# Access Compliance Report

## Public Rights-of-Way (Curb Ramps)

Intersection ID: 10019721	Main Street: ANNAHILL_CT	Cross Street: N/A	Location: NW
ADA ID: F0C76BB4A78B	Ramp Type: BlendTrans1	Initial Pass/Fail: Fail	Overall Compliance: No
Severity Score: 21.25			
Codes/Mitigation Info/Possible Solution		Field Measurements/Component Compliance

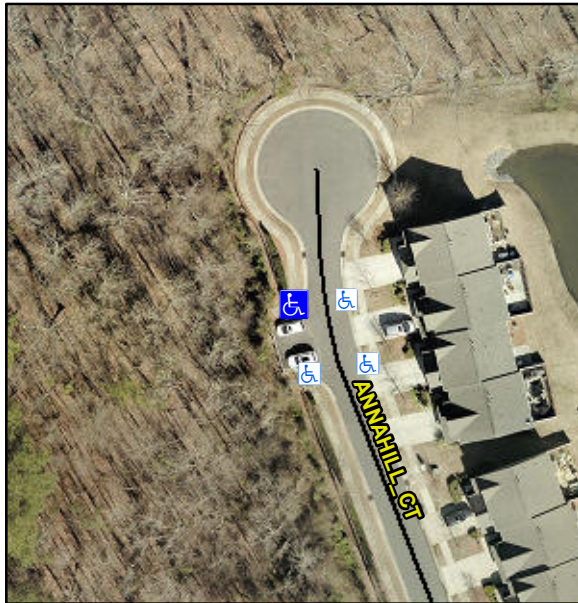
**Remove & Replace Curb Ramp With Two New Directional Ramps or Equivalent.**

**R304.5.1, R304.5.3**

Compliance	Description	Data	Compliance	Description	Data
N/A	Ramp Length (in)	47.0	Yes	BlendTrans Slope (%)	4.5
No	Ramp Width (in)	47.5	No	BlendTrans XSlope (%)	6.2
N/A	Flare Type LT	N/A	N/A	Flare Type RT	N/A
N/A	Flare Slope LT (%)	N/A	N/A	Flare Slope RT (%)	N/A
N/A	Flare Traversable LT?	N/A	N/A	Flare Traversable RT?	N/A
N/A	Landing Length (in)	N/A	N/A	DWS Provided?	N/A
N/A	Landing Width (in)	N/A	N/A	DWS Contrast?	N/A
N/A	Landing Slope (%)	N/A	N/A	DWS Length (in)	N/A
N/A	Landing X Slope (%)	N/A	N/A	DWS Full Width?	N/A
N/A	Landing Curb? (Y/N)	N/A	N/A	DWS Offset (in)	N/A
N/A	Shared Landing?	N/A			
N/A	Gutter Ponding?	N/A	N/A	Gutter Slope (%)	N/A
N/A	Gutter Lip Ht (in)	N/A	N/A	Gutter X Slope (%)	N/A
N/A	Painted X Walk1?	No	N/A	Painted X Walk2?	No
	X Walk 1 Direction	To S		X Walk 2 Direction	To E
	X Walk 1 Width (in)	N/A		X Walk 2 Width (in)	N/A
	X Walk 1 Slope (%)	1.4		X Walk 2 Slope (%)	0.9
	X Walk 1 X Slope (%)	1.5		X Walk 2 X Slope (%)	1.2
